66319D-08

S E R V I C E N O T E

66319D - MOBILE COMMUNICATION DUAL-OUTPUT DC SOURCE, WITH BATTERY EMULATION, DVM. GPIB.

Power-On Self test Errors, Auto reboot, Blank display. No output Communication errors.
No communication when using the GPIB Interface.

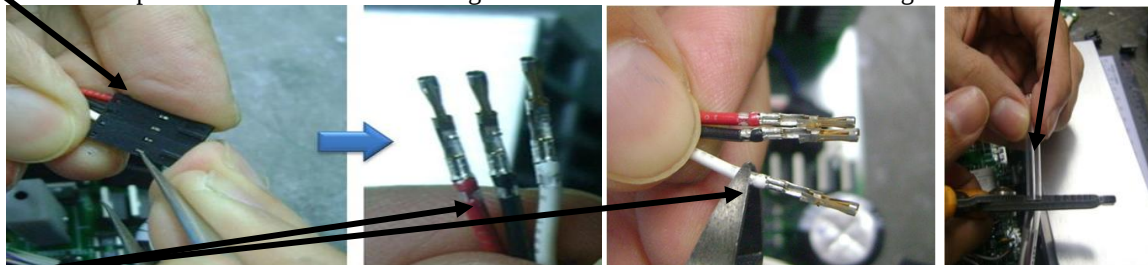
Remove the connector P/N 1252-3695 (circuit reference) "J206" on the "A2" interface assembly. When removing "J206" care should be taken not to damage the "A2" printed circuit board material or the circuit board traces. "J206" has 4 holes remove the solder from these holes as shown. Do not apply too much heat or pressure this may cause damage to the PCA

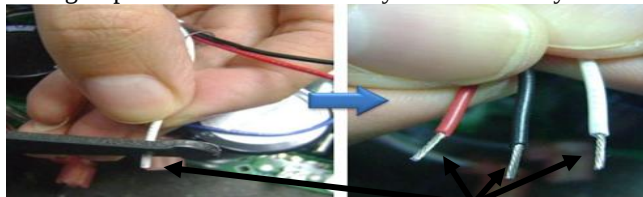
Remove the pins from the connector housing as shown. Cut 3cm off the clear tubing of the cable

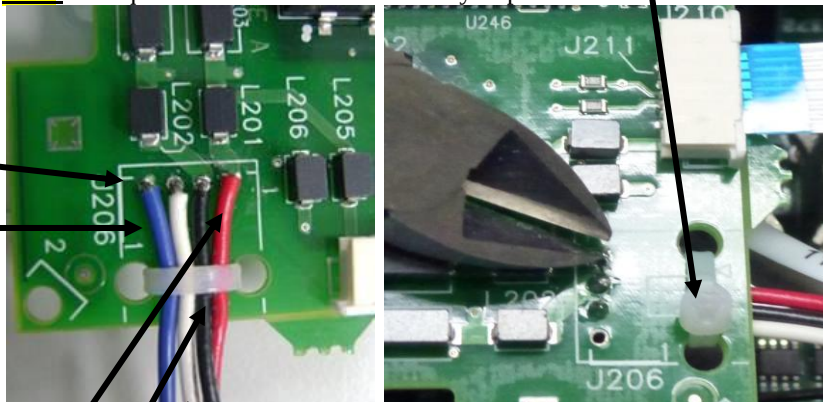
Insert the cable into the open holes located on the “A2” GPIB interface assembly.

Depending on the model there may be three or four wires.

The **Red** wire is soldered in the main control board (reference E320) and should be soldered into pin #1 or the square pad of “J206” on the “A2” interface assembly.

The **Black** wire is soldered in the main control board (reference E324) wire should be soldered into pin #2 of “J206” on the “A2” interface assembly. .

The White wire is soldered in the main control board (reference E321) should be soldered into pin #3 of “J206” on the “A2” interface assembly.

The **Blue** wire is required for the models shown below **ONLY**. This **Blue** wire comes from the connector on the battery emulation board P/N 5064-0131 circuit reference J001 Pin 12, the **Blue** should be soldered into pin # 4 of “J206” for the models listed below only. All other **66300X Mobile Comm DC Sources** only require 3 wires.
